**Evaluation of Erosion and Sediment Control and Stormwater Management
for Gas Exploration and Extraction Facilities in Pennsylvania under
Existing Pennsylvania Regulations and Policies to Determine if Existing
Safeguards Protect Water Quality in Special Protection Waters of the
Delaware Basin
for the Delaware River Basin Commission (DRBC)
Consolidated Administrative Hearing on Grandfathered Exploration Wells**

November 15, 2010

**Delaware Riverkeeper Network
Damascus Citizens for Sustainability**

Michele C. Adams, P.E. LEED AP

Figure 2: Runoff Curve Number for pre and post-development conditions exhibiting increased runoff after construction

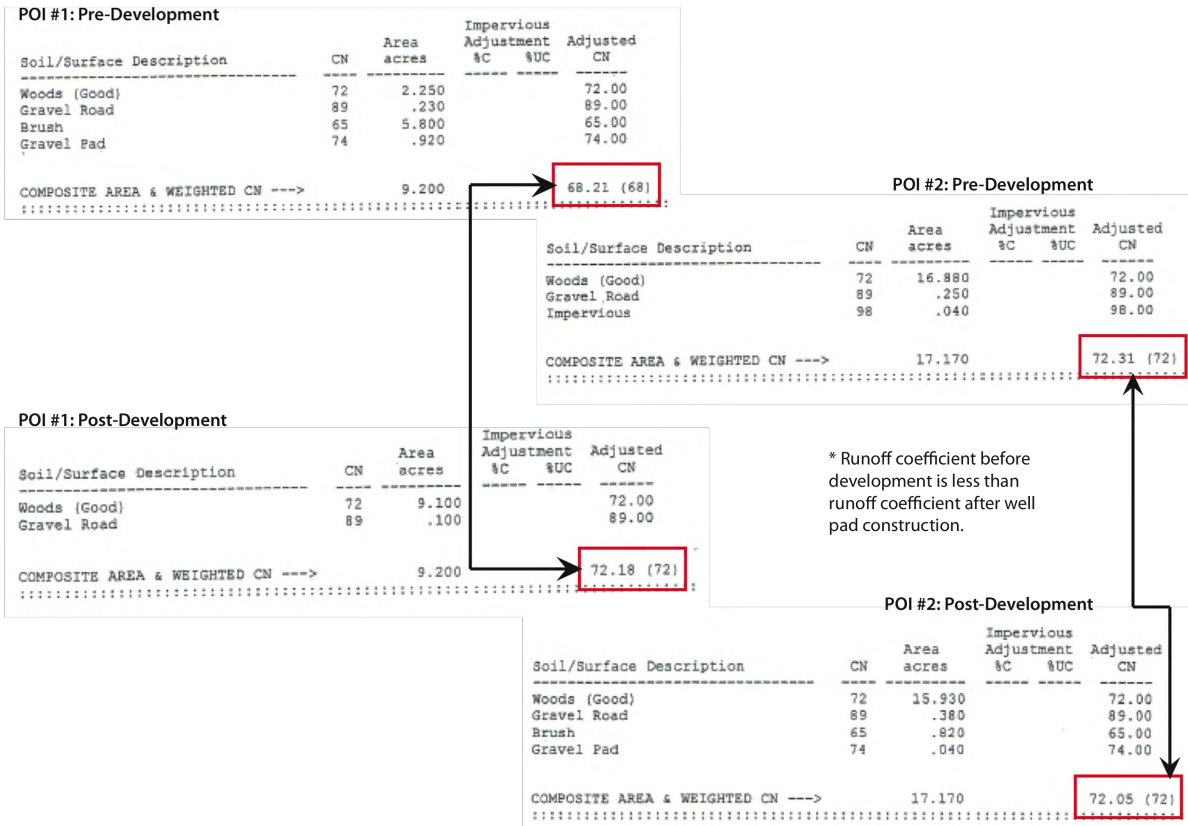
For example, the permit application for the Davidson 1V Well Pad Site indicates that the site will NOT be returned to the original contours and revegetated with pervious material, and therefore, stormwater calculations are required. However, the accompanying stormwater calculations indicate that there will be less stormwater runoff after well pad construction than before. This is not a result of BMPs, but rather a result of applying engineering coefficients (Cover Complex values) that indicate that the site will be more pervious. It is shown in Figure 1 that Essentially, areas that are to be revegetated are calculated as “brush” that produces less runoff than woods in good condition. However, the “Brush Seed Mixture” that is specified is primarily a grass and groundcover seed mix, and does not represent established “brush”, which is shown in Figure 1. A more appropriate runoff coefficient that represents lawn and soils that have been graded would indicate a much greater volume of runoff than is presented. This is shown in Figure 2.

Figure 3. D.L. Teeple 1 1 well, located in Manchester Township, Wayne

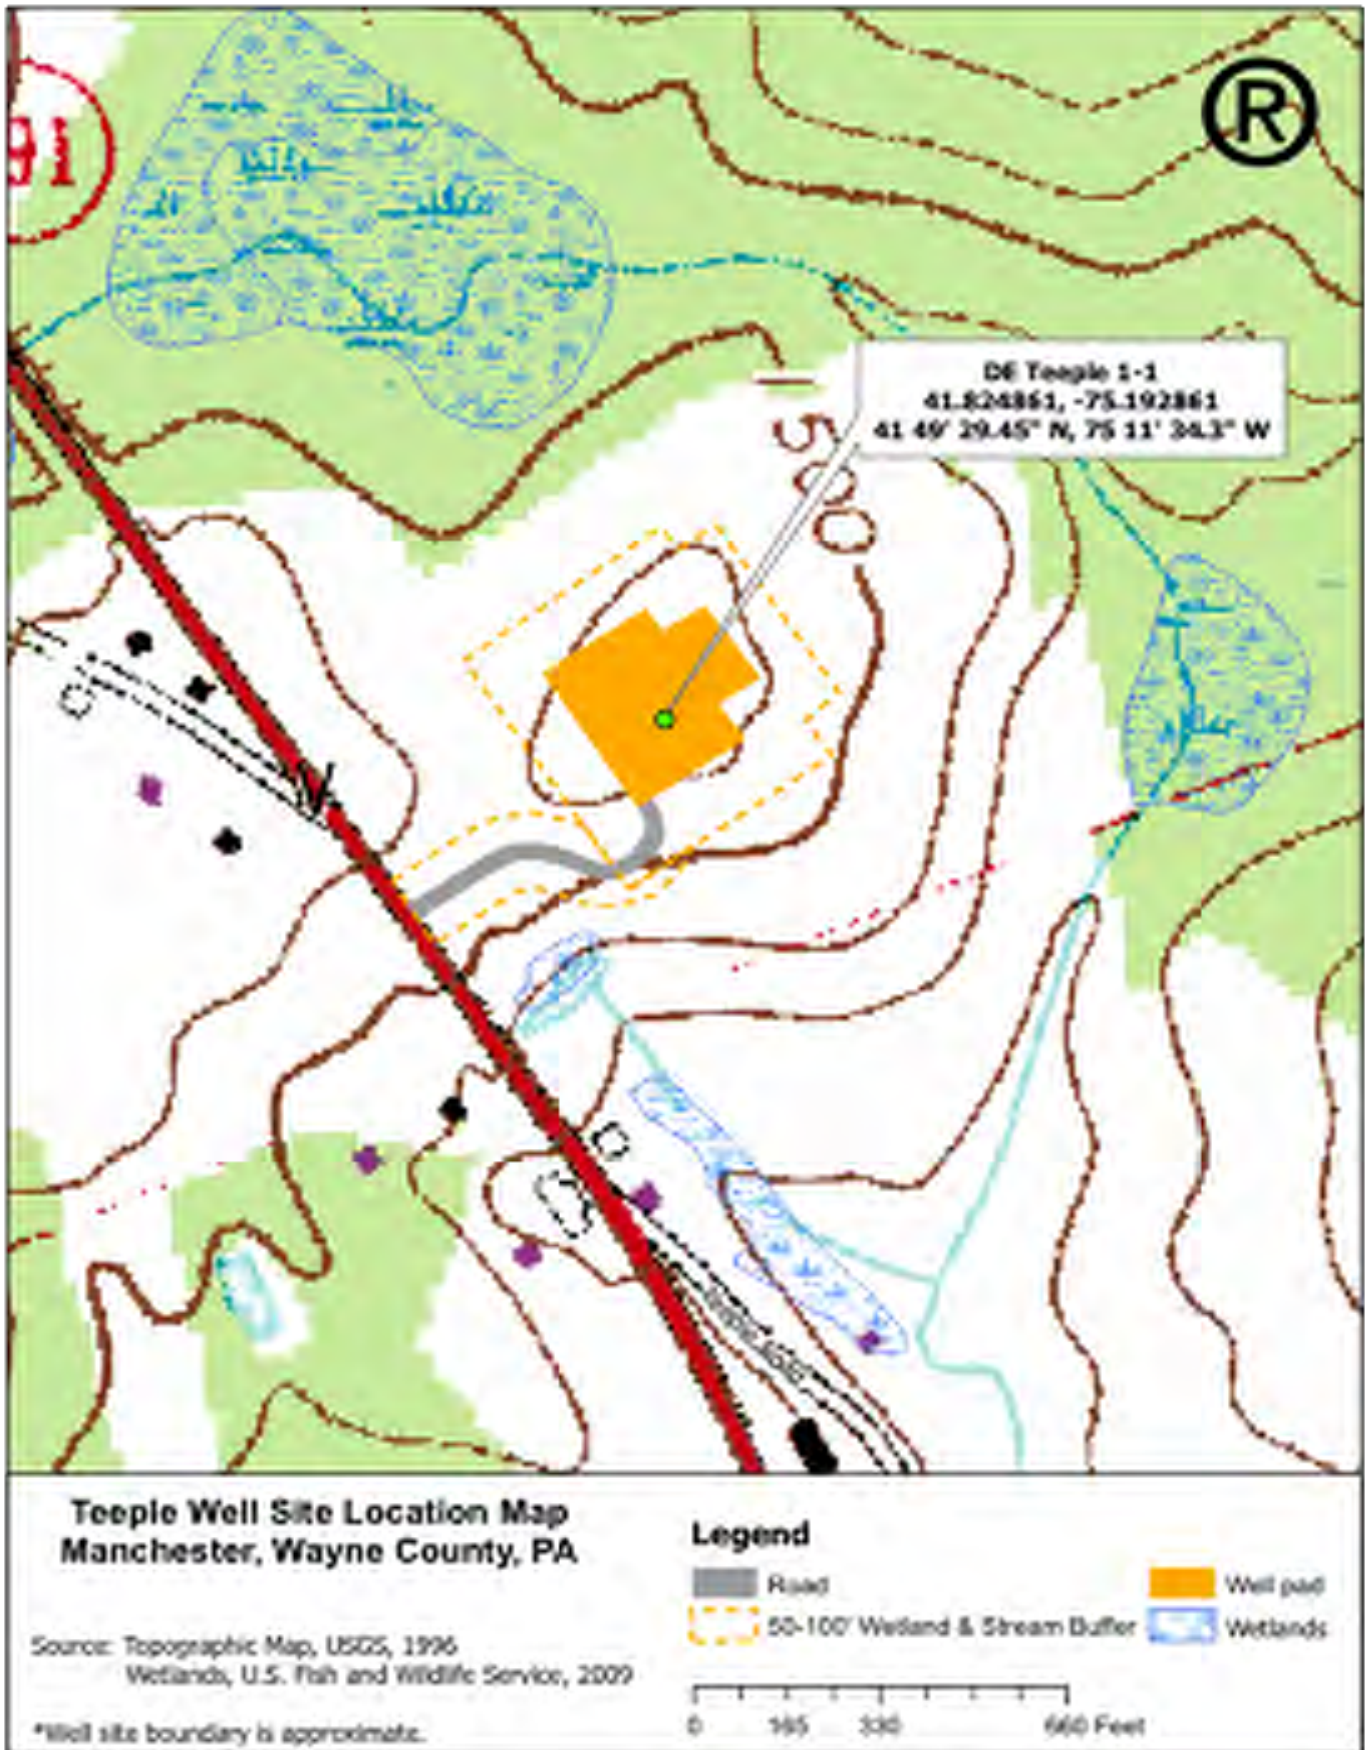
The potential impacts to water quality can be seen in the existing D.L. Teeple 1 1 well, located in Manchester Township, Wayne County and owned by Newfield Appalachia PA LLC (permit # 37-127-20013, issued on April 23, 2010), shown as Figure 1. This well is located in the Shehawken Rattlesnake Creek, designated in Pennsylvania as High Quality (HQ). The permit application for this well indicates under Item 8 of the "Permit Application for Drilling or Altering a Well" that the well site is not within 100 feet (horizontally) of a stream, spring, or water body of water delineated on the most current 7-1/2 minute topographic map. As can be seen by the overlay of the Well Location Plat onto a USGS 7-1/2 minute quadrangle map, the well pad is not within 100 feet of a body of water as indicated on the USGS 7-1/2 minute quad, but it is situated at the top of a hill surrounded on three sides by streams and wetlands that are delineated on the quad map. The site is bordered on the western side by S.R. 191, and a wetland can be seen just over 100 feet downhill from the construction entrance.

Given the topography and surrounding surface waters at the Teeple 1 1 site, there is significant potential for discharge of sediment and other pollutants to surface waters if erosion and sediment control measures are not actively maintained and implemented.

This well location was cited on 5/26/2010 for a violation of Chapter 102. 4 for "Failure to minimize accelerated erosion, implement E&S Plan, maintain E&S controls. Failure to stabilize site until total restoration under OGA Sec 206(c)(d)." This violation was issued just over one month after the permit was issued. A second violation was also issued on 5/26/2010 under Pa Code 78 for an improperly lined pit.
